Interactive comment on “Transition of flow regime along a marine-terminating outlet glacier in East Antarctica” by D. Callens et al.

Interactive comment on “Transition of flow regime along a marine-terminating outlet glacier in East Antarctica” by et al.

R.G. Bingham (Referee) r.bingham@ed.ac.uk Received and published: 23 November 2013

Fig. 1. Fig 3

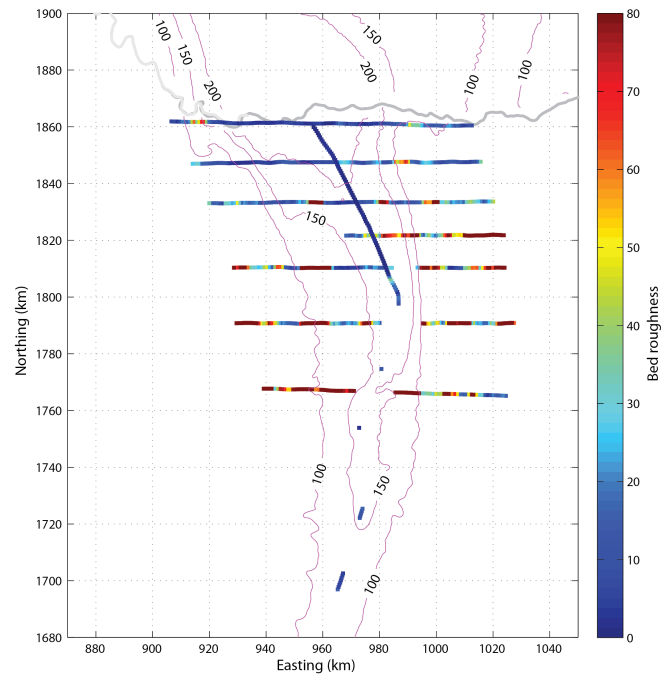
[REF] Fig. 3 This diagram would be really helped if some surface-velocity contours could be added to guide the viewer as to the main flow over the area, so as better to compare with the subglacial roughness signal. [AUTHOR] Done See figure uploaded.
